Access Compliance Report

Public Rights-of-Way

(Curb Ramps)

Intersection ID: 20280	Main Street: CEDAR_HILL_DR	Cross Street: LARIX_DR	Location: NE
ADA ID: EC649E489993	Ramp Type: PerpDiag	Initial Pass/Fail: Fail	Overall Compliance: No
Severity Score: 13.75			
Codes/Mitigation Info/Possible Solution		Field Measurements/Component Compliance

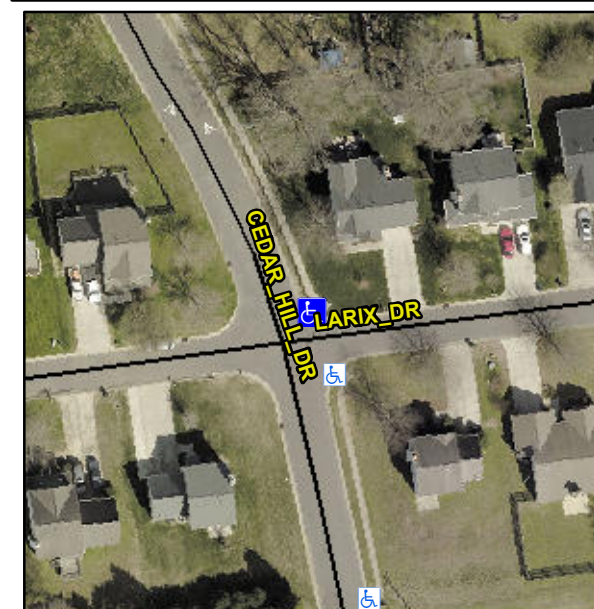
Compliance	Description	Data	Compliance	Description	Data
N/A	Ramp Length (in)	47.0	No	Ramp Slope (%)	8.9
Yes	Ramp Width (in)	52.0	No	Ramp XSlope (%)	3.1
N/A	Flare Type LT	N/A	N/A	Flare Type RT	N/A
N/A	Flare Slope LT (%)	N/A	N/A	Flare Slope RT (%)	N/A
N/A	Flare Traversable LT?	N/A	N/A	Flare Traversable RT?	N/A
N/A	Landing Length (in)	N/A	N/A	DWS Provided?	N/A
N/A	Landing Width (in)	N/A	N/A	DWS Contrast?	N/A
N/A	Landing Slope (%)	N/A	N/A	DWS Length (in)	N/A
N/A	Landing X Slope (%)	N/A	N/A	DWS Full Width?	N/A
N/A	Landing Curb? (Y/N)	N/A	N/A	DWS Offset (in)	N/A
N/A	Shared Landing?	N/A			
N/A	Gutter Ponding?	N/A	N/A	Gutter Slope (%)	N/A
N/A	Gutter Lip Ht (in)	N/A	N/A	Gutter X Slope (%)	N/A
N/A	Painted X Walk1?	No	N/A	Painted X Walk2?	No
	X Walk 1 Direction	To W		X Walk 2 Direction	To S
N/A	X Walk 1 Width (in)	N/A	N/A	X Walk 2 Width (in)	N/A
	X Walk 1 Slope (%)	6.9		X Walk 2 Slope (%)	3.7
	X Walk 1 X Slope (%)	0.1		X Walk 2 X Slope (%)	4.9

N/A	Ramp inside XWalk1?	N/A	N/A	Ramp inside XWalk2?	N/A
	Road Slope (%)	3.2	N/A	Clear Space?	N/A
	Road X Slope (%)	8.5	N/A	Clear Space to XWalk (in)	N/A
N/A	Any Obstructions?	N/A	N/A	Storm Grate/Utility Hazard?	N/A
	Obstruction Type			Storm Grate/Utility Type	
		N/A			N/A
		Yes		Surface Condition? (G/P)	Good

Remove & Replace Curb Ramp With Two New Directional Ramps or Equivalent.
